TRANSMITTAL OF RESPONSES TO COMMENTS AND THE REVISED PROJECT SPECIFIC PLAN FOR DIRECT-PUSH GROUNDWATER SAMPLING IN FORMER SOIL EXCAVATION AREAS

**RESPONSES TO
U.S. AND OHIO ENVIRONMENTAL PROTECTION AGENCY
COMMENTS ON THE PROJECT SPECIFIC PLAN FOR
DIRECT-PUSH GROUNDWATER SAMPLING IN
THE FORMER SOIL EXCAVATION AREAS
(REVISION 0)**

**FERNALD CLOSURE PROJECT
FERNALD, OHIO**

FIGURE 1. PROPOSED DIRECT-PUSH GROUNDWATER SAMPLING LOCATIONS IN GMA BENEATH EXCAVATION AREAS 3A AND 4A

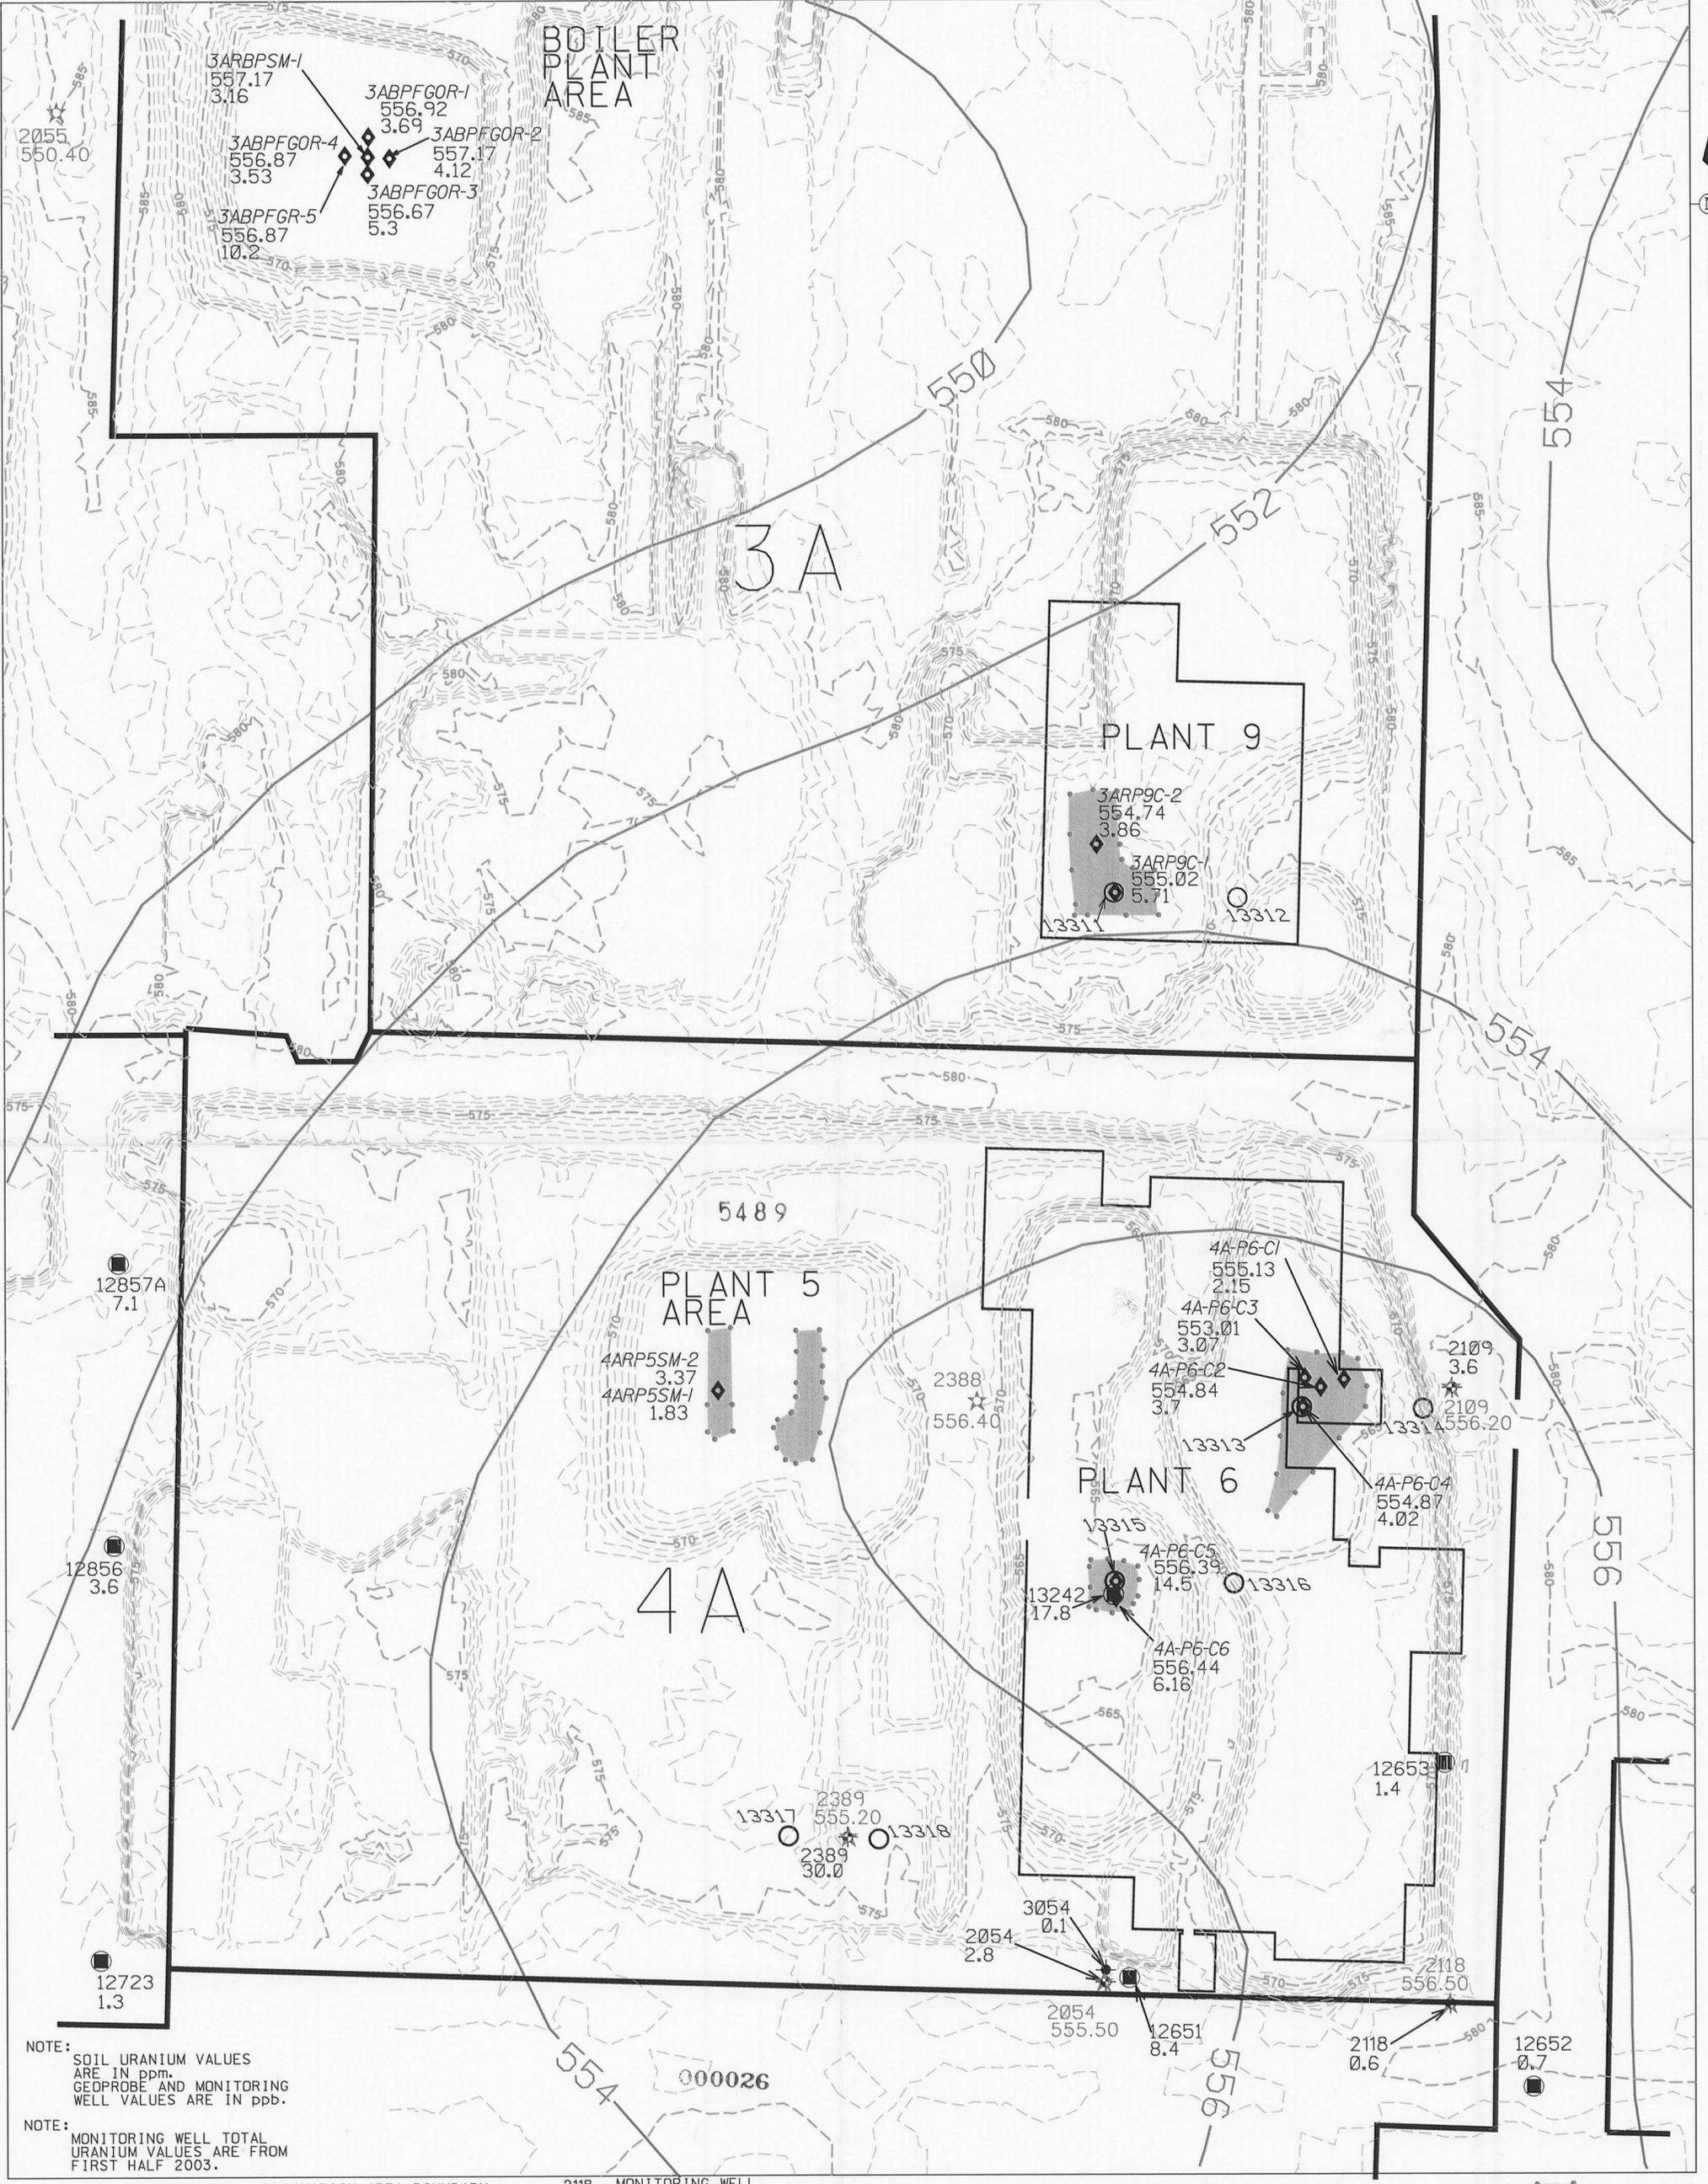
table. Trading a deep push for several shallower pushes is not a valid trade off from a cost perspective. Once set up at a location the cost for going deeper is much less than setting up at another location. Additional sampling locations can be identified and sampled if data from the locations already identified indicates a need to do so.

Action: The PSP was revised to reflect the shallower sampling depth. A copy of the revised PSP is enclosed with this comment response document.
